STAFF REPORT
COMMUNITY DEVELOPMENT DEPARTMENT

HEARING DATE: 1/2/2023
TO: Mayor & City Council
FROM: Stacy Hersh, Associate Planner
208-884-5533
SUBJECT: Centerville No. 2
FP-2023-0022
LOCATION: Southeast corner of S. Hillsdale and E. Amity, in the NW ¼ of the NE ¼ of Section 33, Township 3N., Range 1E.

Final plat consisting of 47 single-family residential building lots and 8 common lots on 12.30 acres of land in the R-8 and R-15 zoning districts for Centerville Subdivision No. 2.

B. Final Plat (date: 10/18/2023)

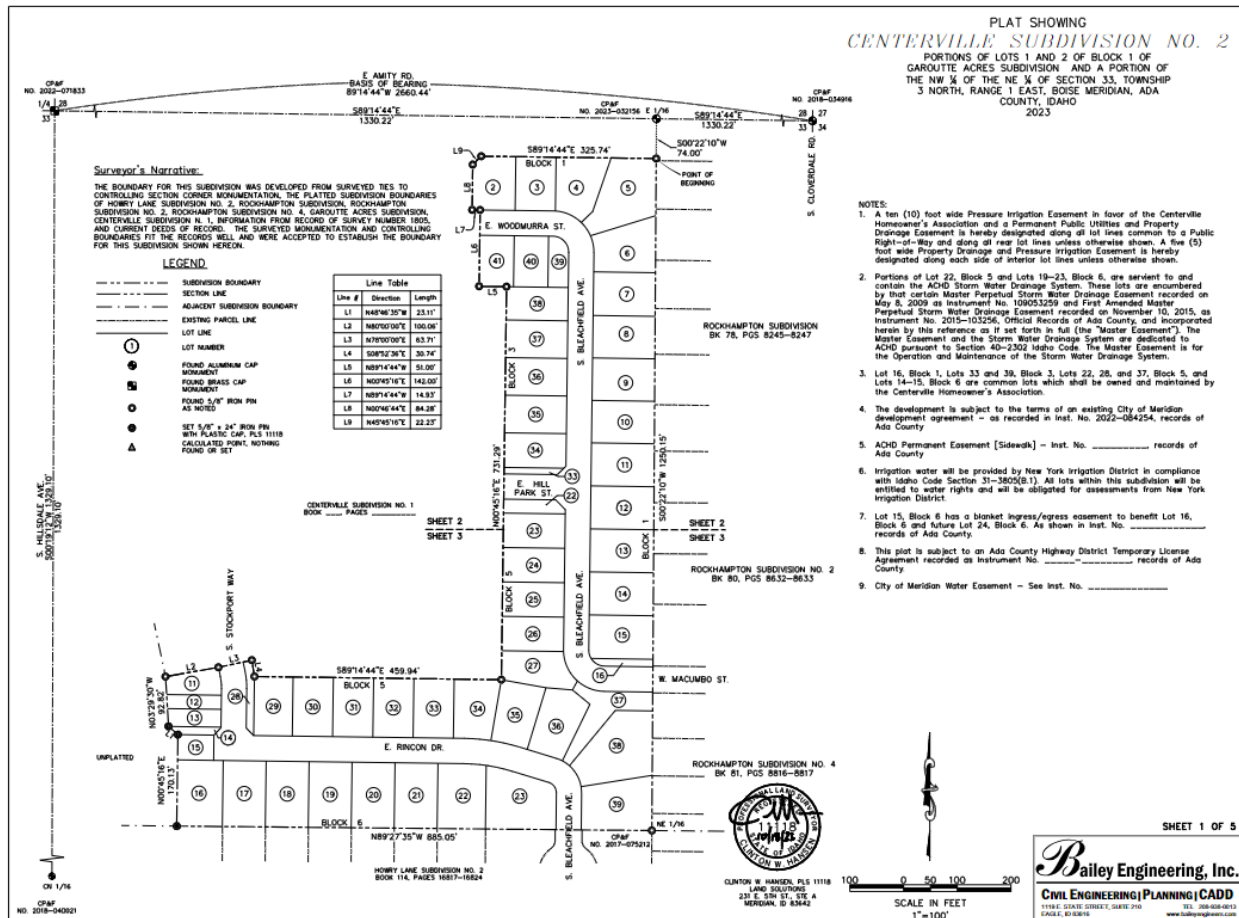
3. Prior to submittal for the City Engineer's signature, have the Certificate of Owners and the accompanying acknowledgement signed and notarized.
4. The final plat shown in Section V.B prepared by Clinton W. Hansen Bailey Engineering, Inc., shall be revised as follows:

- a. Note #5: Include the recorded instrument number of the ACHD permanent easement for the sidewalk.
 - b. Revise Note #7 to read: "Lot 15, Block 6 is for a private street for the benefit of Lot 16, Block 6."

- c. Note #8: Include the recorded instrument number of the ACHD temporary license agreement.
 - d. Note #9: Include the recorded instrument number of the City of Meridian Utility easement.

- e. Add #10: Include the recorded instrument number of the existing City of Meridian Development Agreement.

OVERALL PLAN

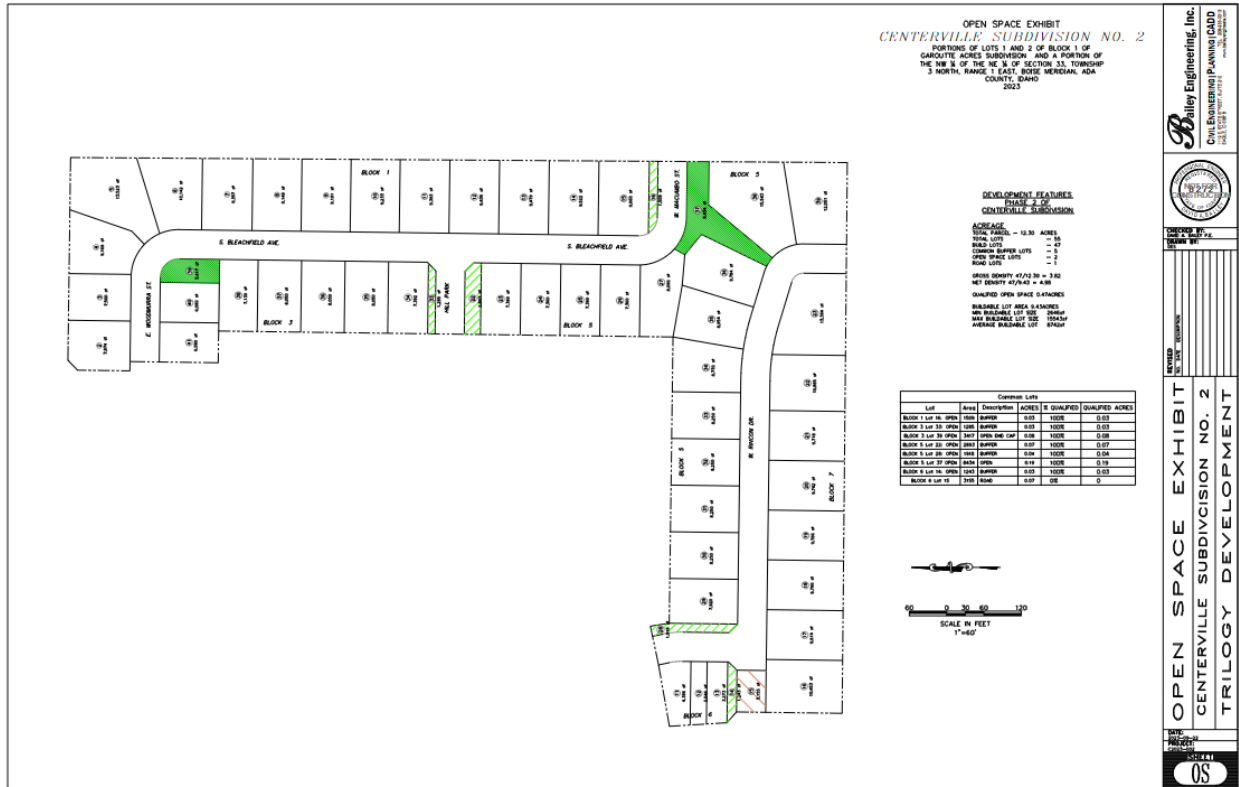
5. The landscape plan shown in Section V.C, dated 10/18/23 prepared by Jensen Belts Associates, PLLC, shall be revised as follows:
 - a. Include mitigation calculations on the plan for existing trees that are proposed to be removed in accord with the standards listed in UDC [11-3B-10C.5](#). The Applicant shall coordinate with the City Arborist (Kyle Yorita kyorita@meridiancity.org) to determine mitigation requirements *prior* to removal of existing trees from the site.
6. **The private street located on Lot 15, Block 6 was approved with the preliminary plat, and a tentative approval was granted for the private street application (A-2021-0222). The Applicant shall provide the following documentation in accordance with UDC 11-3F-3 prior to City Engineer's signature on the final plat for the private drive.**
